Access Compliance Report Public Rights-of-Way (Curb Ramps)

Main Street: VINEYARD_RD Cross Street: CALDWELL_LN Location: NE

ADA ID: RPAT211103112451 Ramp Type: Type 4 - Parallel Initial Pass/Fail: Fail Overall Compliance: No Severity Score: 16

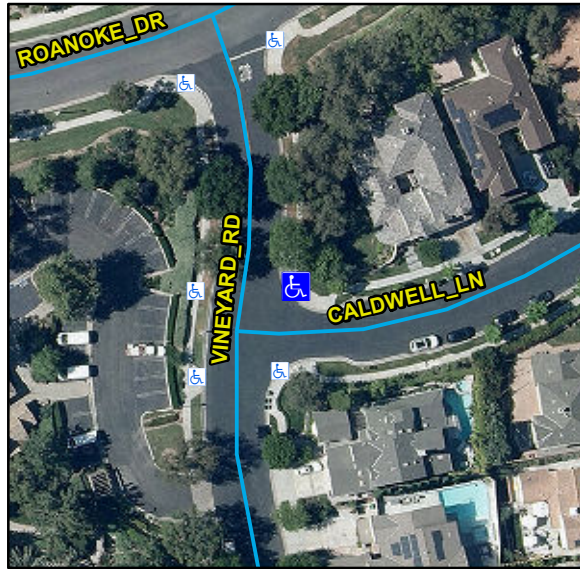
R204.3, R304.3.2, R304.5.3, STD 1115

Compliance	Description	Data	Compliance	Description	Data
N/A	Ramp Length LT (in)	105	N/A	Ramp Length RT (in)	105
Yes	Ramp Width LT (in)	90	Yes	Ramp Width RT (in)	90
No	Ramp Run Slope LT (%)	12	Yes	Ramp Run Slope RT (%)	1.4
No	Ramp Cross Slope LT (%)	2.9	Yes	Ramp Cross Slope RT (%)	1.4
N/A	Landing Present	N/A	N/A	DWS Provided	N/A
N/A	Landing Length (in)	N/A	N/A	DWS Contrast	N/A
N/A	Landing Width (in)	N/A	N/A	DWS Length (in)	N/A
N/A	Landing Run Slope (%)	N/A	N/A	DWS Full Width	N/A
N/A	Landing Cross Slope (%)	N/A		DWS Offset Type	N/A
N/A	Landing Movement Obstructed?	N/A	N/A	DWS Offset Left (in)	N/A
	Landing Movement Type	N/A	N/A	DWS Offset Right (in)	N/A
N/A	Landing Shared	N/A			
N/A	Clear Space	Yes			
N/A	Clear Space To Crosswalk (in)	N/A			
N/A	Marked Crosswalk 1	No	N/A	Marked Crosswalk 2	No
	Crossing 1 Direction	W		Crossing 2 Direction	S
	Marked Crosswalk 1 Width (in)	N/A		Marked Crosswalk 2 Width (in)	N/A

Remove & Replace Curb Ramp With Two New Directional Ramps or Equivalent.
